CITY OF DOVER

PLANNING TECHNICAL REVIEW COMMITTEE –AGENDA

1. 10:30 AM – 11:00 AM: Site Review Amendment for John Kniphfer (Owner: Kniphfer, LLC) Assessor's Map L, Lot 55-A, zoned R-12, located at 43 Back River Road. (Proposal is for a daycare use and to install a second driveway to help with traffic flow at drop off and pick up with associated parking.) (WAIV-2023-0004).
2. 11:00 AM – 11:45 AM: Site Review for Cooperative Alliance for Seacoast Transportation (COAST), (Assessor's Map H, Lot 35-C-4, located at 42 Sumner Drive. (Proposal is to build a 28,700 s.f vehicle storage building and 17,000 s.f. administration, operations and maintenance building.) (SITE-2023-0002). [*This item was previously heard on 04/06/2023*]
3. Immediately Following: Discussion on Industrial Pretreatment Compliance Inspections as part of Technical Review Committee Review

A&M Project #: 3188-01
Re: Site Plan Amendment for Childcare Center
Tax Map I, Lot 55-A
43 Back River Road

drawing no.
C-4

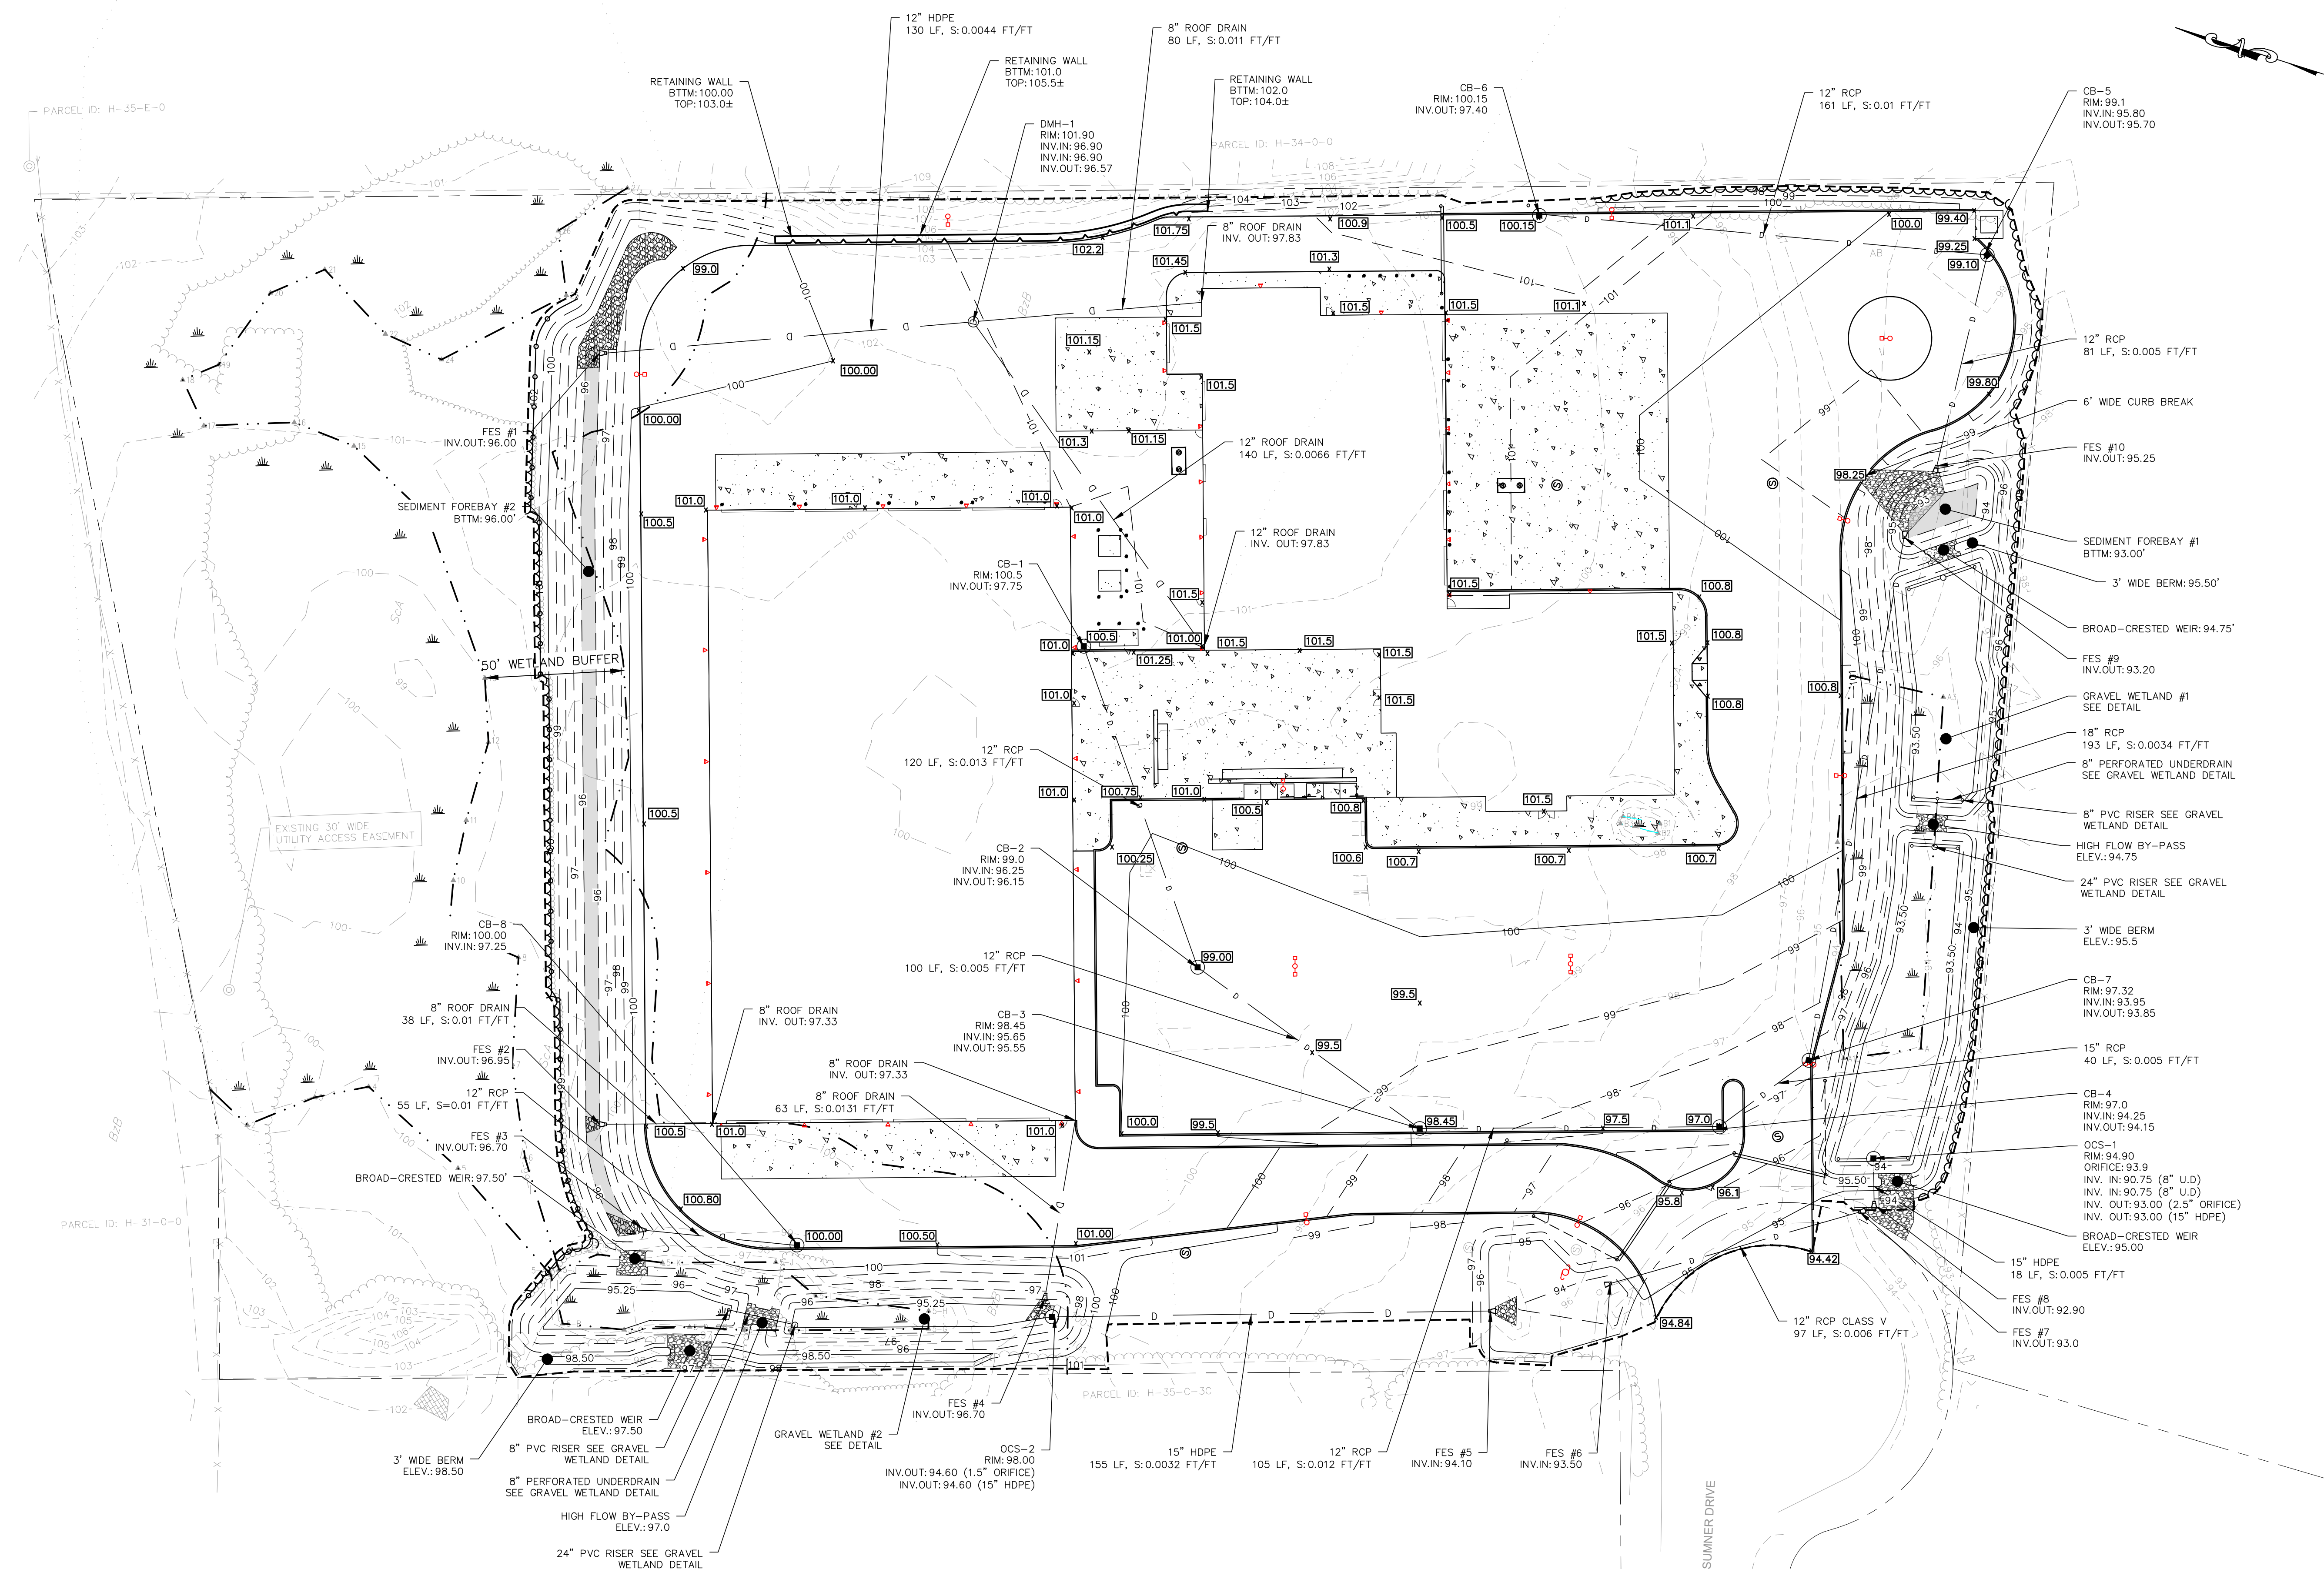
- Sheet C-4: Clarify how long narrow sediment forebay will flow towards the two treatment bays on the northern side of the site. It appears that there is room to shift the treatment bays to the south and create a more traditional sized forebay.

- Sheet C-4: ADA spaces have less than 1% cross slopes.
- Sheet C-4: How will stormwater flow out of the paved pedestrian area between the buildings. Add spot grades to show positive drainage.

- Sheet C-4: There is a 6 ft curb break near FES 10. Recommend either adding rip rap to protect the slope from washing out or CB with pipe.
- Sheet C-4: All FES shall have a rip rap apron sized according to DES standards. Provide calcs as required by DES AOT.

- Sheet C-4: Retaining wall is shown at nearly 7 feet. Provide detail for wall and clarify with geotextile is required.
- Sheet C-5: Revise perimeter barrier to stay within the limits of the Limit of Work.

- 30. Sheet C-3: Please show the existing hydrant in the cul-de-sac.**
The existing hydrant has been added to the plan set.
- 31. Sheet C-4: Clarify how long narrow sediment forebay will flow towards the two treatment bays on the northern side of the site. It appears that there is room to shift the treatment bays to the south and create a more traditional sized forebay.**
The forebay itself can be reconfigured to be smaller, as it is currently oversized. We have opted to leave the configuration as is for this submittal to accommodate the proposed roof drain. We are open to discussing a shallower roof drain, thereby allowing a smaller forebay that will be more traditionally sized.

- 32. Sheet C-4: ADA spaces have less than 1% cross slopes.**
The grading has been revised to have a minimum cross slope of 1%.
- 33. Sheet C-4: How will stormwater flow out of the paved pedestrian area between the buildings. Add spot grades to show positive drainage.**
Additional spot grades have been added to show drainage direction.

- 34. Sheet C-4: There is a 6 ft curb break near FES 10. Recommend either adding rip rap to protect the slope from washing out or CB with pipe.**
Riprap / outlet protection has been added to all curb breaks and flared end sections.

- 35. Sheet C-4: All FES shall have a rip rap apron sized according to DES standards. Provide calcs at required by DES AOT.**
Riprap calculations have been provided as part of this resubmittal.

- 36. Sheet C-4: Retaining wall is shown at nearly 7 feet. Provide detail for wall and clarify with geotextile is required.**
A retaining wall detail has been added to the last detail sheet of the plan set.

Drainage Pipe
Not to Scale

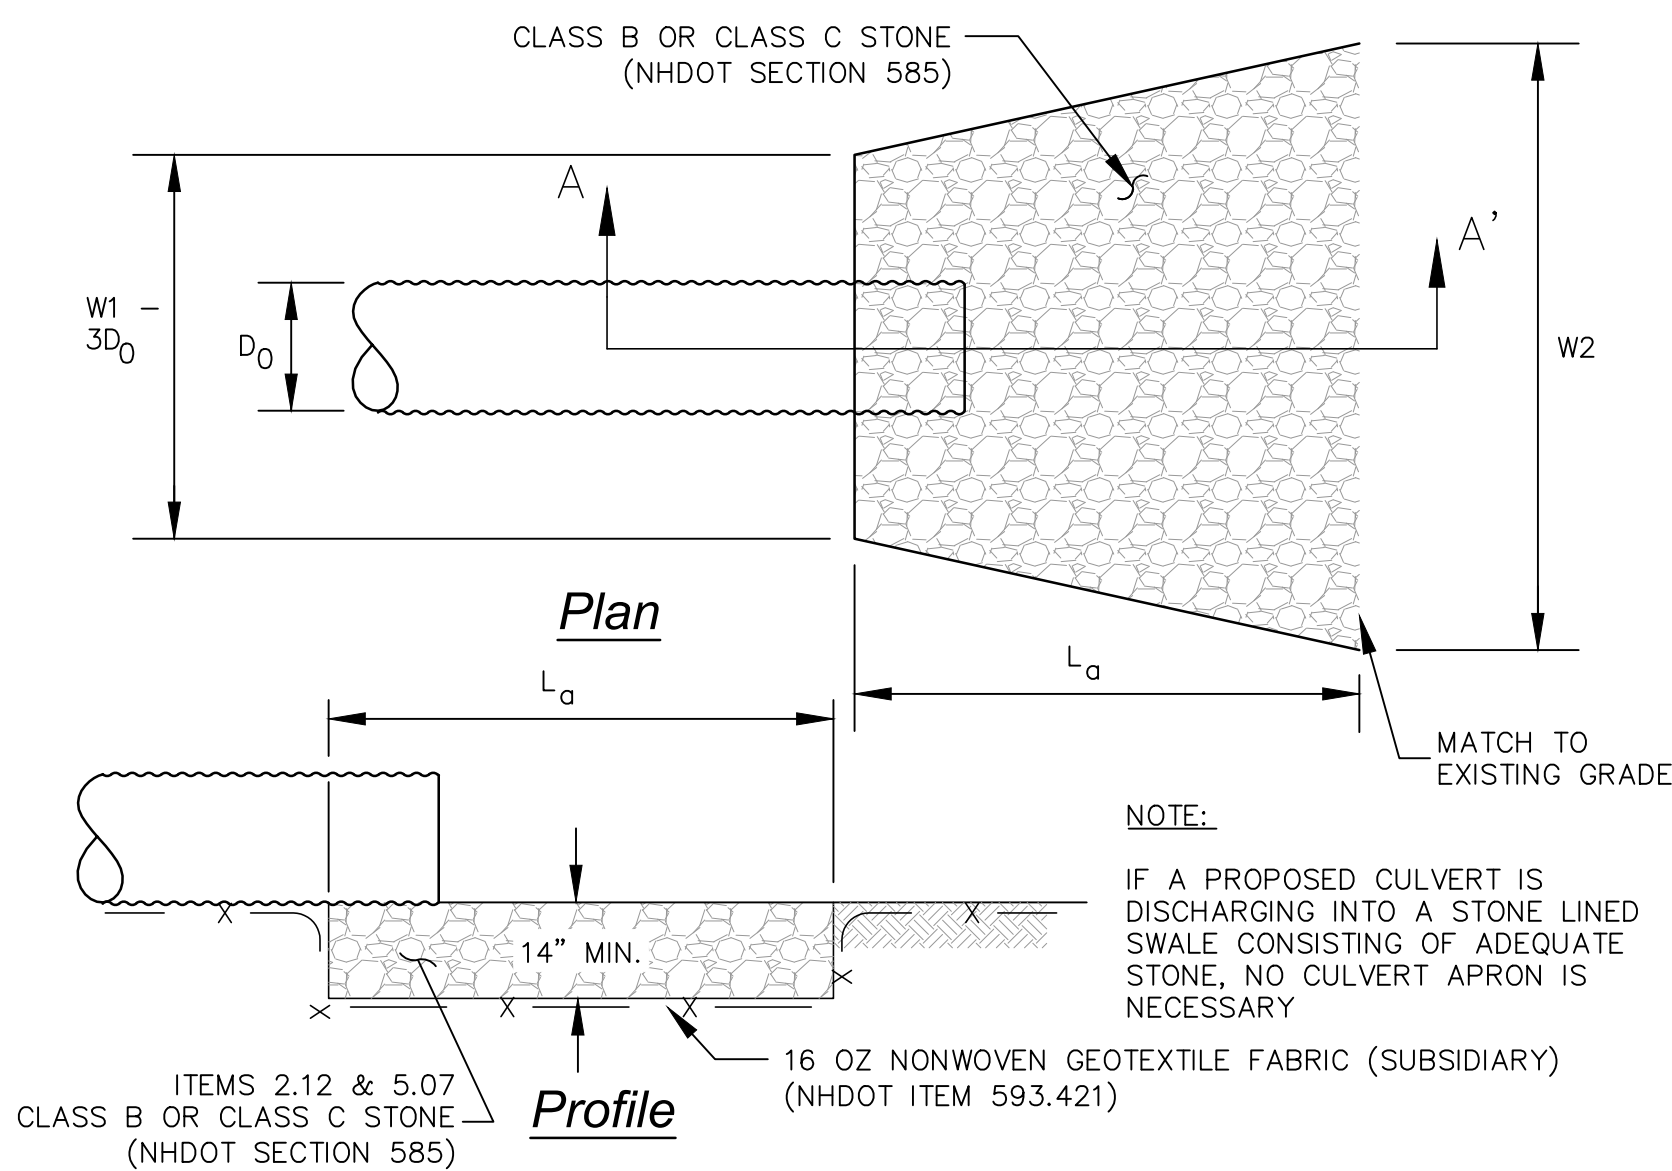
- Sheet D-5: Drain Manhole: Brick invert not required.
- Sheet D-5: Drainage Pipe: Revise trench detail to meet City standard. Stone backfill must be placed above pipe.

- 45. Sheet D-5: Drain Manhole: Brick invert not required.**
The brick invert has been removed from the drain manhole detail.
- 46. Sheet D-5: Drainage Pipe: Revise trench detail to meet City standard. Stone backfill must be placed above pipe.**
The detail has been modified to match the City standard detail.
